220001 - Pilu 80 Undercliff Road Freshwater - Response to Council RFI - R1

TO: Giovanni Cirillo **DATE:** 18 September 2024
COMPANY: -
EMAIL: -
FROM: Matthew Furlong
SUBJECT: **Pilu, 80 Undercliff Road, Freshwater – Response to Council RFI – September 2024**

Pulse White Noise Acoustics Pty Ltd (PWNA) has been requested to undertake a review and response in relation to the *Northern Beaches Council Environmental Health Unit Referral Response* dated 23rd August 2024 for the DA2024/0946.

Figure 4 Extract – PWNA Pilu Acoustic Assessment

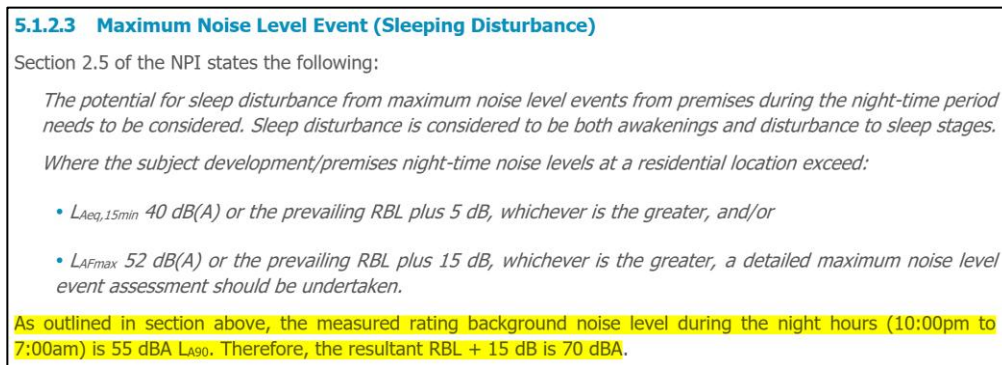
- Paragraph 3:
 - A lack of understanding of the site and associated development application is evident in the RSA comment. The site does not contain any “industrial” or “carparks”.
 - In relation to the mechanical plant, compliance is already achieved. Again, no alterations to this existing system are currently proposed.
 - No further comment required.
- Paragraph 4 & 5:
 - The criteria are not incomplete. Refer to the report and the extract provided below.
 - No further comment required.
